RE: Johnson/PLN210061

Re: Response to Peer Review Comments for
Proposed Development at 226 Highway 1
Carmel Highlands, California
Monterey County APN 241-182-003

SUBJECT: RESPONSE TO PEER REVIEW COMMENTS

Photographs

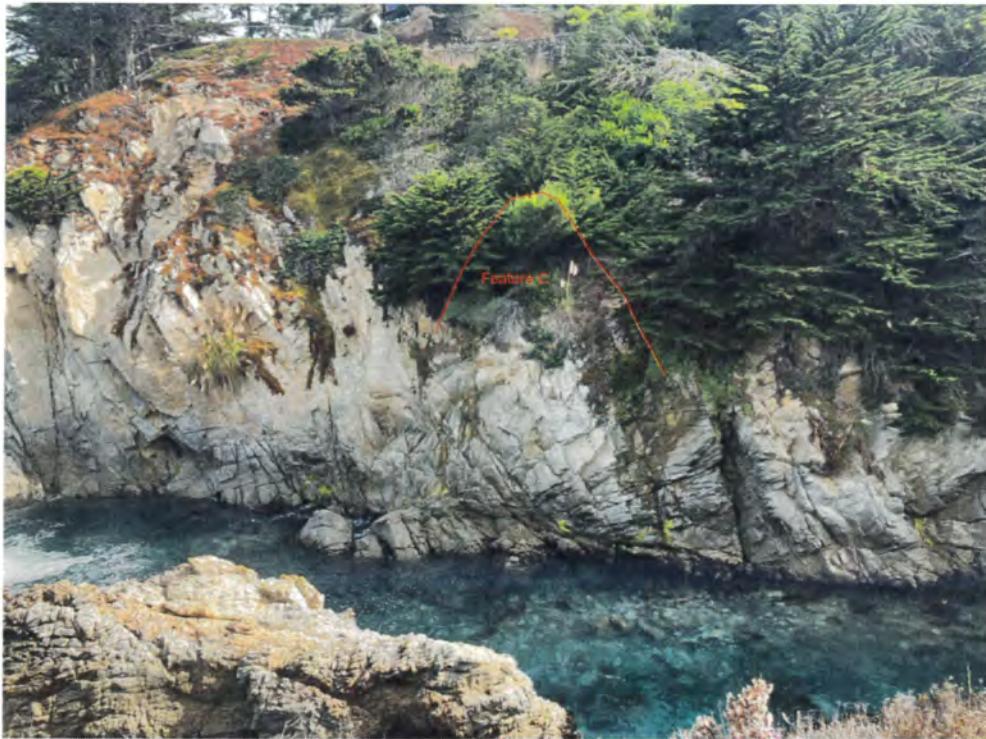
Feature A – A deposit of Coal.

Easton Geology Response: Old alluvium (Qoal) was encountered in Exploratory Shaft 1 and is exposed in the bluff face below the site. The alluvial deposit infills an old, narrow, hillside swale. Similar ancient, infilled swales are visible in roadcuts above Highway 1 near the site. Where exposed in the bluff-face, the old alluvium is stratified and clasts are imbricated. The bluff-face exposure is unsupported yet maintains a steep slope similar to the adjacent granite and marine terrace deposits. As encountered in Exploratory Shaft 1, the alluvium is dense, normally graded, and its clay matrix is stiff. The alluvium encountered in the shaft and exposed in the bluff face is matrix supported in the upper portion of the deposit and becomes clast supported in the lower portion. We saw no shearing or offsets within the old alluvium. The soil profile exposed in the cutslope through the infilled swale in the southeastern portion of the property (above the autocourt) reveals a well developed pedogenic soil. None of the above observations are suggestive of the old alluvium or the swale it infills as resulting from landsliding. We interpret the alluvial deposits to be at least 125,000 years old based on their geomorphic position above a Pleistocene marine terrace, and they are believed to grade with the marine terrace deposits below.

Figure 5 Project Elevation Profile

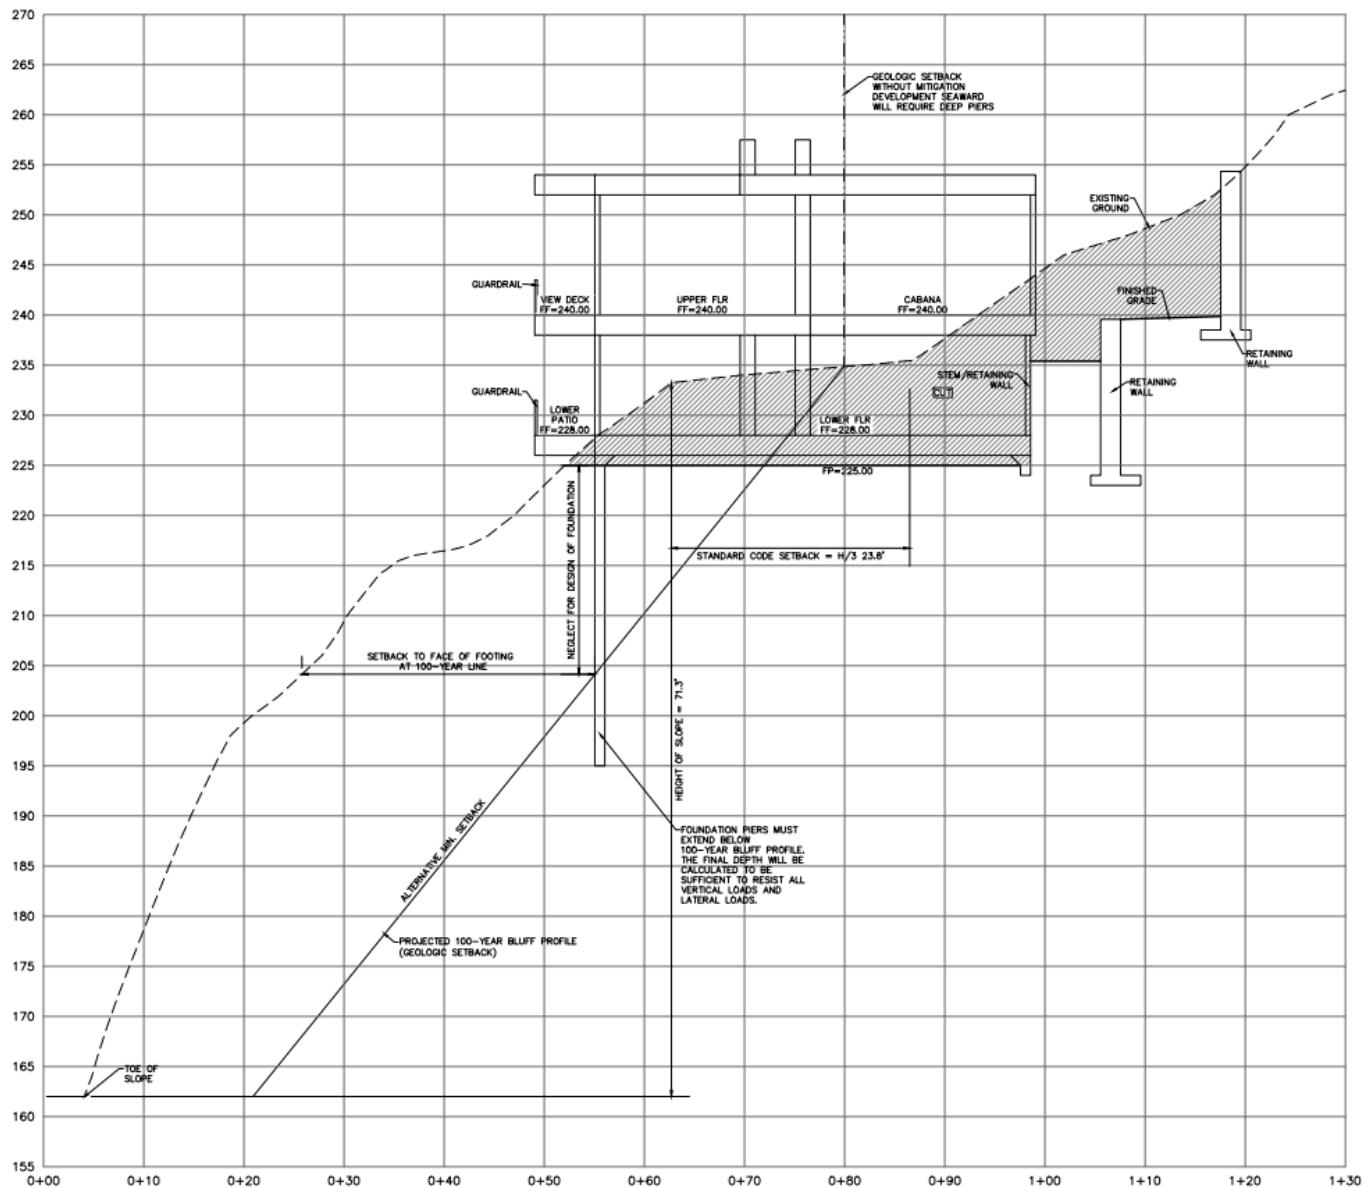
¹ Figure 5 (Project Elevation Profile) of the MND shows how the majority of the Project extends beyond the geologic setback line, protruding over the steep coastal cliff face. A copy of this figure is attached hereto as Exhibit A.
